Access Compliance Report

(Curb Ramps)

Intersection ID: 31250	Main Street: DAVID_COX_RD	Cross Street: HARRIS_COVE_DR	Location: N
ADA ID: 0559102CD722	Ramp Type: Perp	Initial Pass/Fail: Fail	Overall Compliance: No
Severity Score: 8.75			
Codes/Mitigation Info/Possible Solution		Field Measurements/Component Compliance

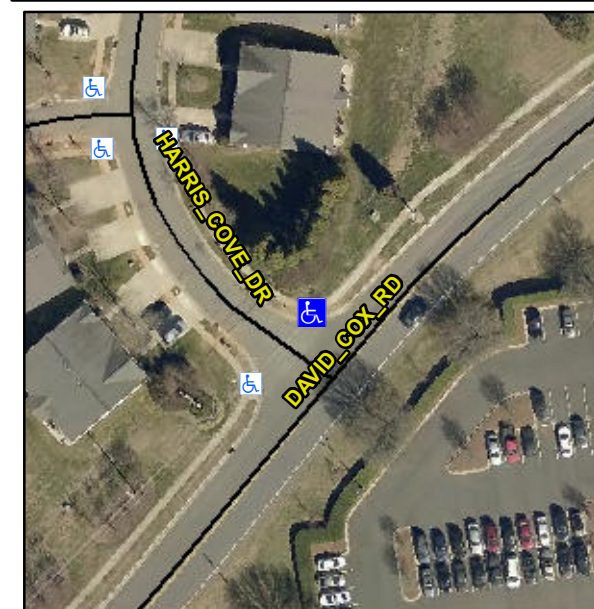
Compliance	Description	Data	Compliance	Description	Data
N/A	Ramp Length (in)	48.0	Yes	Ramp Slope (%)	7.9
No	Ramp Width (in)	43.0	Yes	Ramp XSlope (%)	0.3
N/A	Flare Type LT	N/A	N/A	Flare Type RT	N/A
N/A	Flare Slope LT (%)	N/A	N/A	Flare Slope RT (%)	N/A
N/A	Flare Traversable LT?	N/A	N/A	Flare Traversable RT?	N/A
N/A	Landing Length (in)	N/A	N/A	DWS Provided?	N/A
N/A	Landing Width (in)	N/A	N/A	DWS Contrast?	N/A
N/A	Landing Slope (%)	N/A	N/A	DWS Length (in)	N/A
N/A	Landing X Slope (%)	N/A	N/A	DWS Full Width?	N/A
N/A	Landing Curb? (Y/N)	N/A	N/A	DWS Offset (in)	N/A
N/A	Shared Landing?	N/A			
N/A	Gutter Ponding?	N/A	N/A	Gutter Slope (%)	N/A
N/A	Gutter Lip Ht (in)	N/A	N/A	Gutter X Slope (%)	N/A
N/A	Painted X Walk1?	No	N/A	Painted X Walk2?	N/A
	X Walk 1 Direction	To SW		X Walk 2 Direction	N/A
N/A	X Walk 1 Width (in)	N/A	N/A	X Walk 2 Width (in)	N/A
	X Walk 1 Slope (%)	0.1		X Walk 2 Slope (%)	N/A
	X Walk 1 X Slope (%)	1.2		X Walk 2 X Slope (%)	N/A

Remove & Replace Entire Ramp.

R304.5.1
